SMITHGROUP

ADDENDUM

PROJECT	UWST Esports Bid Documents	ADDENDUM NUMBER	1
PROJECT NO.	L-24-001	DATE	3/27/2025
PROJECT LOCATION	Menomonie WI		
OWNER	UW Systems / UW Stout		
PREPARED BY	Sam Kreuser		
TOTAL PAGE COUNT	22

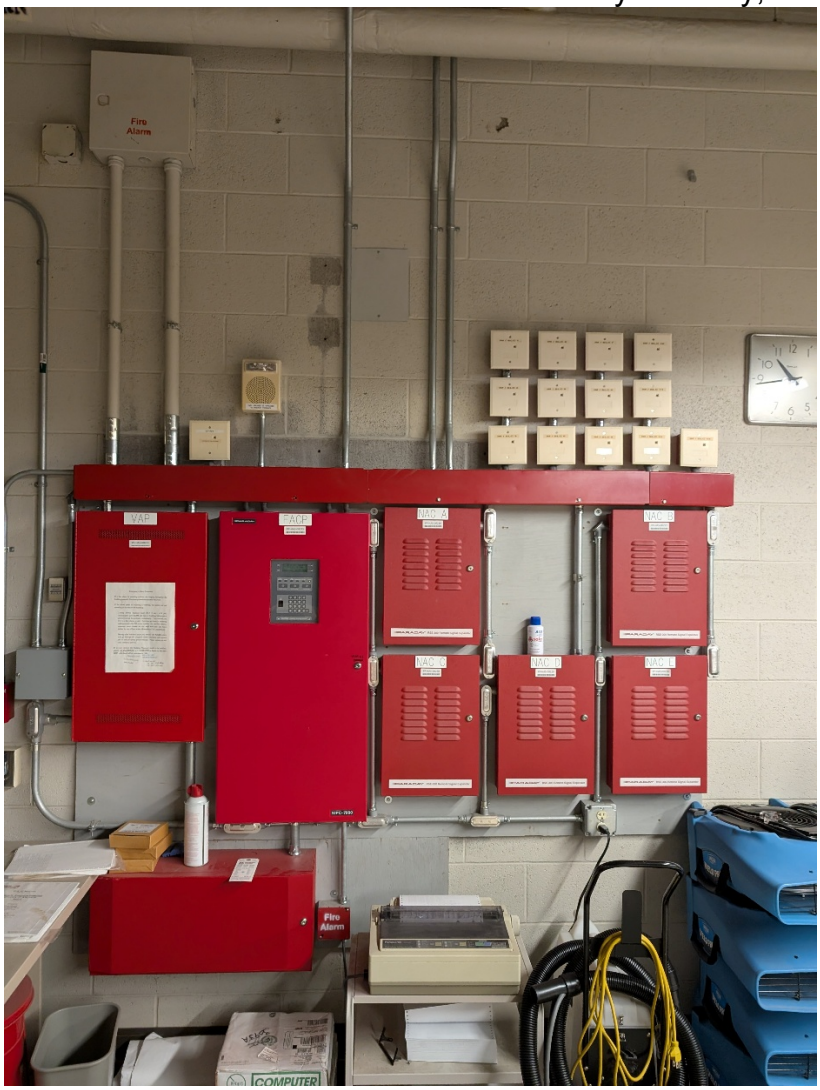
4. Who is the Fire Alarm Manufacturer and where are the panels located?
   a. Answer: The main panel is located in room 314 as described in note FA202 on sheet FA1.1. Panels are manufactured by Faraday, image for reference:
   b.

1 FIRST FLOOR - LIFE SAFETY PLAN
SCALE: 3/32" = 1'-0"

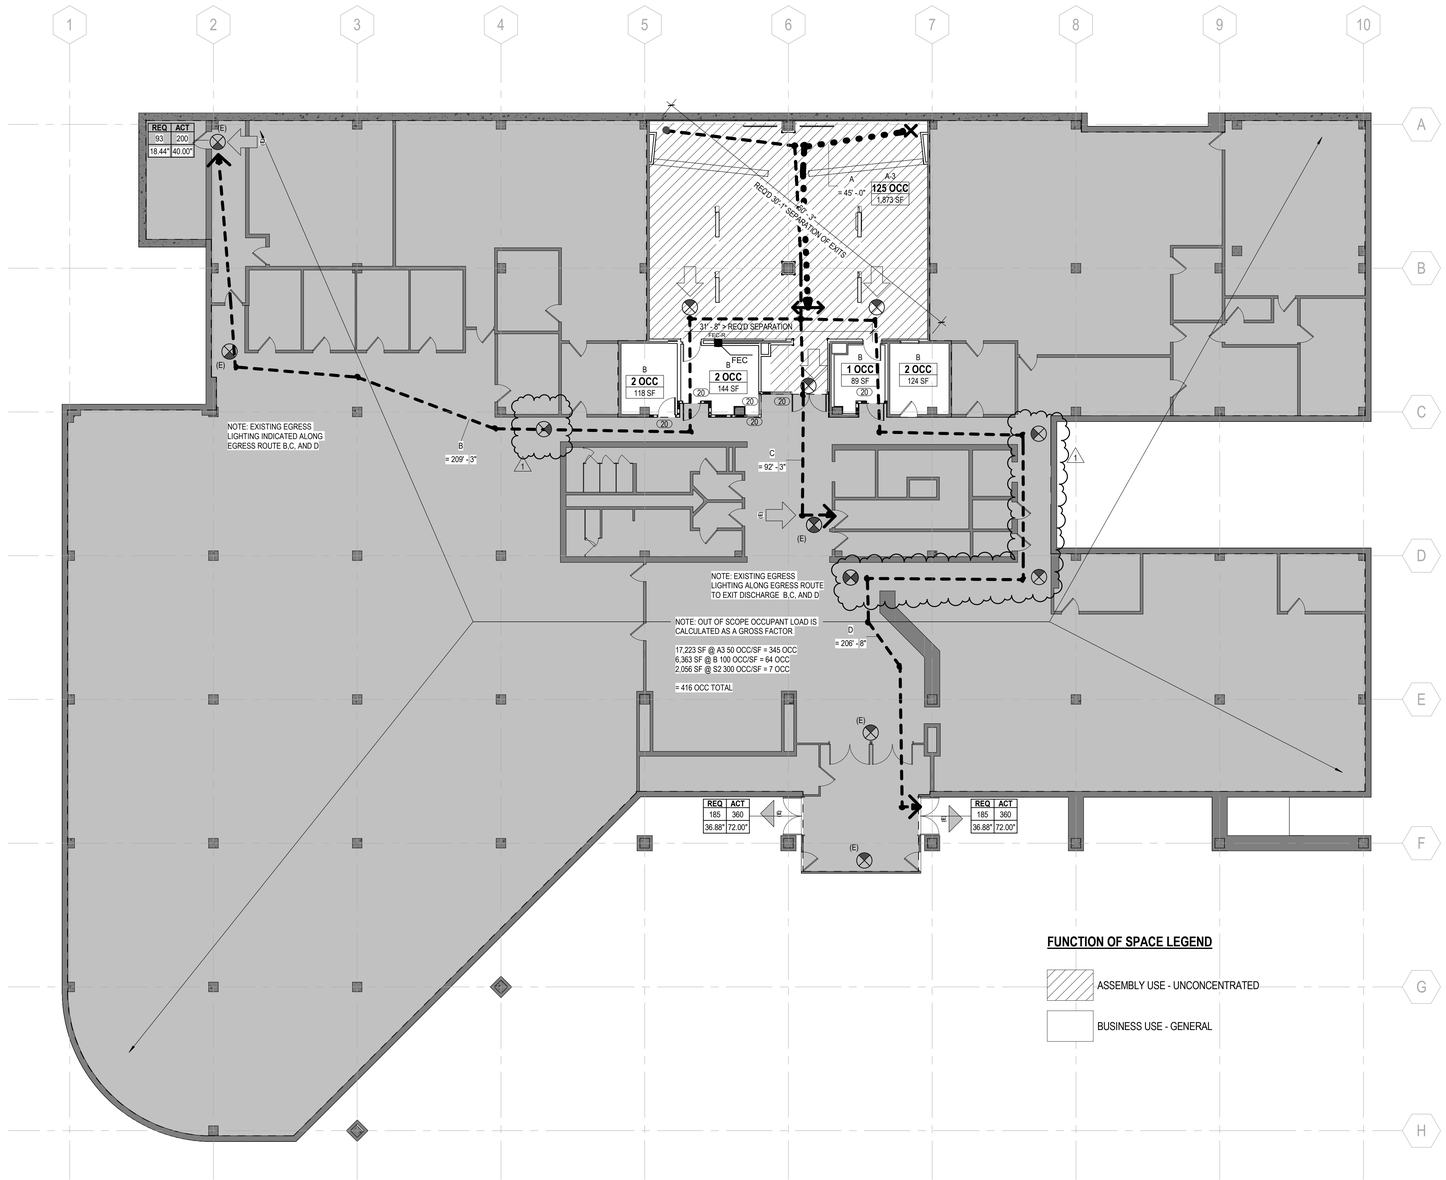
3.2 REVISED DRAWING SHEETS
- A. G2.1.1 – Added three exit signs along egress route “D” and one along route “B”
- B. AD2.1.1 – Revised note AD117
- C. A2.1.1 – Added dimensions and frame type to door 111.1 side lite and corner glazing at Broadcast Control
- D. A8.1.1 – Added height dimension and frame type for door 111.1 side lite and corner glazing at Broadcast Control
- E. A8.1.2 - Added height dimension and frame type for door 111.1 side lite and corner glazing at Broadcast Control
- F. A9.3.1 – Replaced Aluminum Frame details with Hollow Metal details.
- G. A9.4.1 – Removed “Sound Absorbing Panels” from Detail 9
- H. AI1.1.0 – Changed AWP-01 and LKR-01 to “NOT USED”
- I. E2.1 – Added new dedicated AV receptacle in Broadcast Control 111A.
- J. E7.1 - Added circuit GP-1-44 for new dedicated AV receptacle in Broadcast Control 111A.

4.1 Added new type X2 exit signs in corridor 100B and rooms 100, 102, and 123.

1 FIRST FLOOR - FLOOR PLAN AREA A
SCALE: 1/4" = 1'-0"

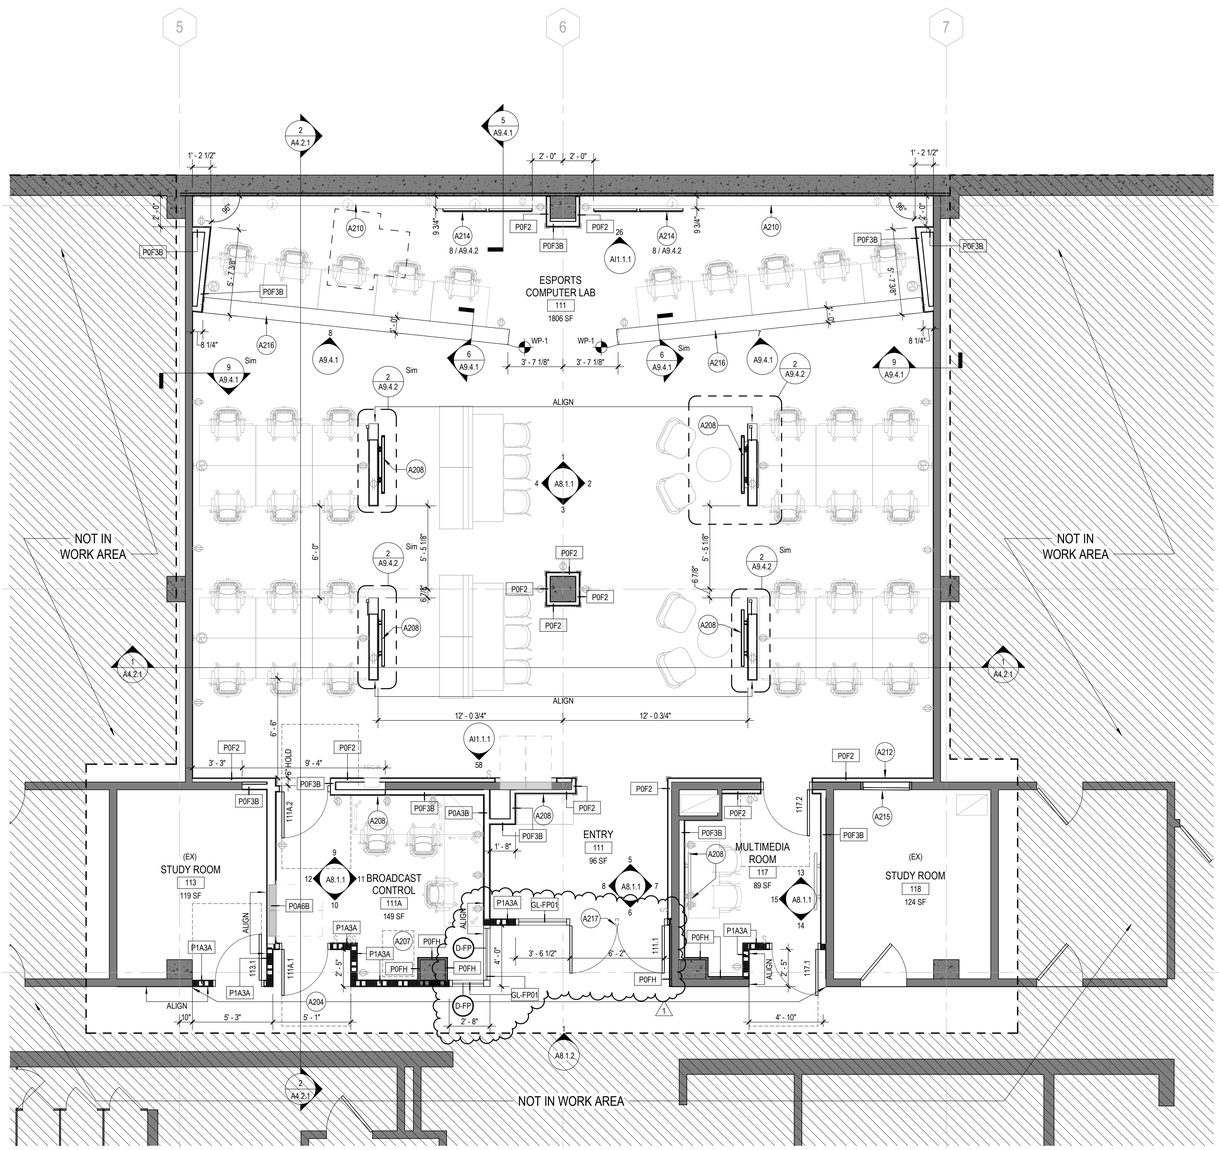
4.2 Added detail for frame material and size for corner glazing at Broadcast Control. The frame and glazing are 20 min rated, provide two sections 2’-8” Wide x 7’-2” Tall and 4’-0” Wide x 7’-2” Tall. Added dimension for sidelite at door 111.1 and modified the frame elevation to show double door with removable mullion.

1 FIRST FLOOR - LIGHTING PLAN
SCALE: 1/8" = 1'-0"

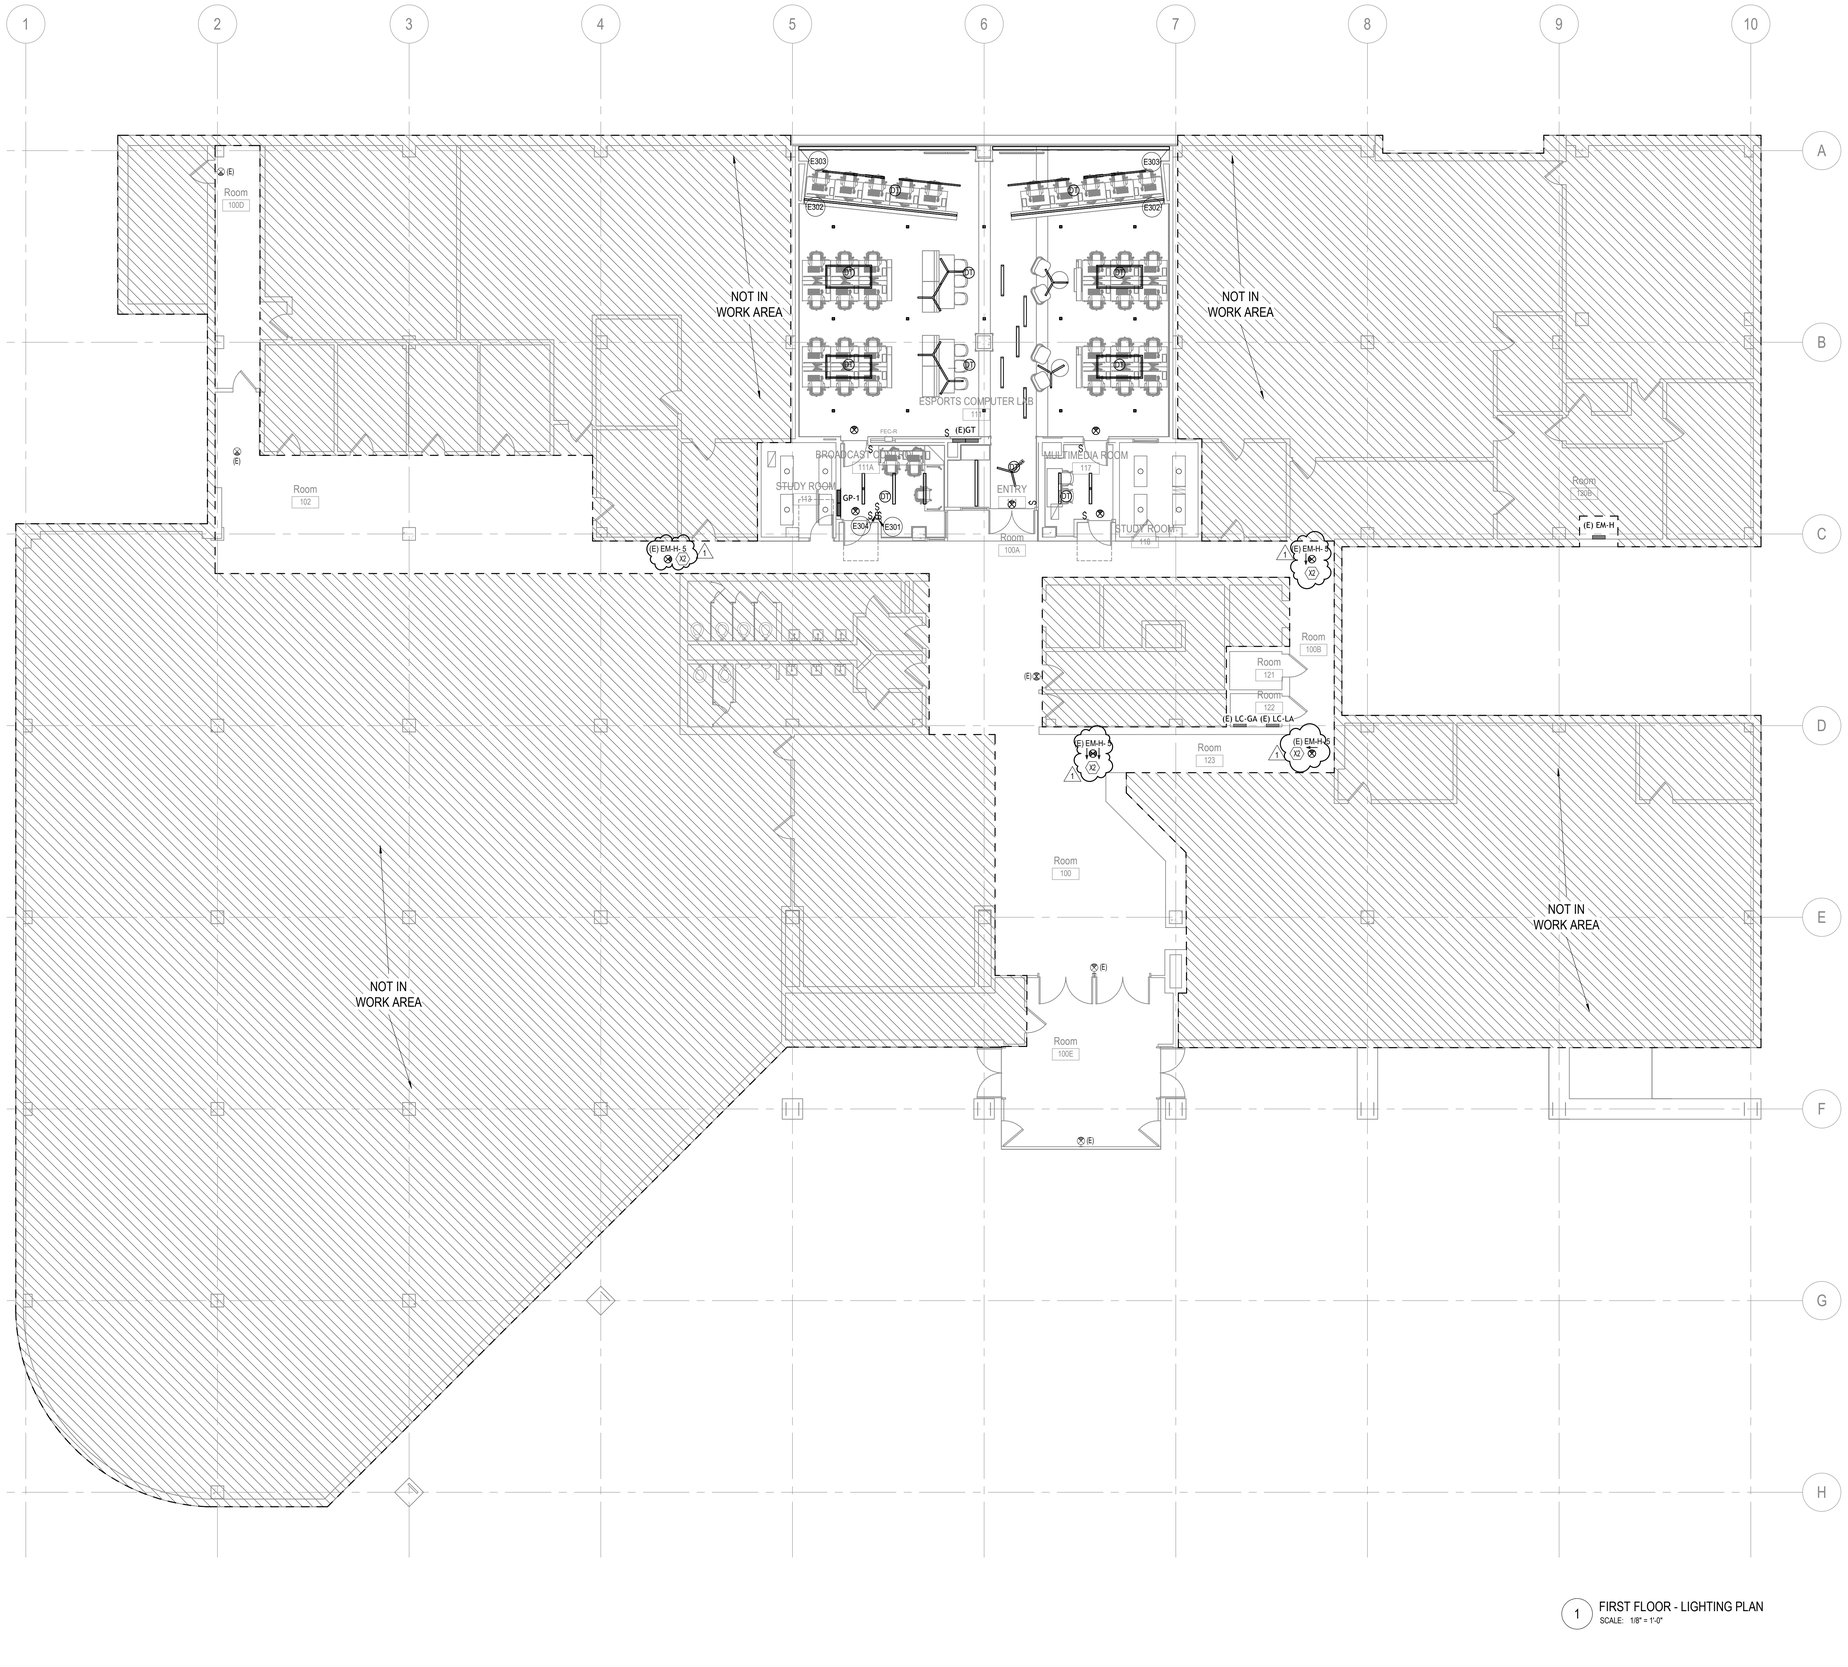
A. E3.1 – Changed this sheet to overall floor view for new corridor exit signs
B. E3.2 – New sheet for previous E3.1 Esports arena enlarged view
